California ISO	Business Requirements Specification Responses to Stakeholder Questions/Comments	Template Version:	5.0
		Document Version:	1.0
FERC Order 2222		Date Created:	9/9/2024

*Responses to stakeholder input for the **FERC Order 2222 Business Requirements Specification**, as received during the designated commenting period, are provided in the table below.*

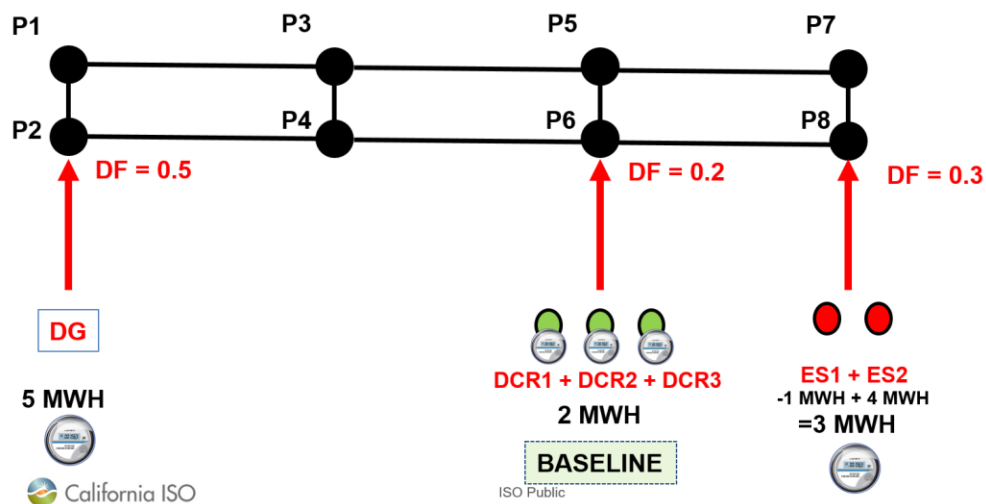
Item	From	Org	Submit Date	BRQ REF	Question	Response
13	Kevin Ou	PG&E	7/24/2024 10:36:27 AM	BRQ007	Can CAISO provide an example of the mathematical equation on how the HDERAs' combined baseline is calculated?	<p>An HDERA's demand curtailment resource DCR has multiple baseline calculation options. These are exemplified in the Demand Response BPM in Section 5 and explained in the CAISO tariff section 4.13.4 Performance Evaluation Methodologies for PDRs and RDRRs.</p> <p>Link to DR BPM: https://bpmcm.caiso.com/Pages/BPMDetails.aspx?BPM=Demand%20Response</p>
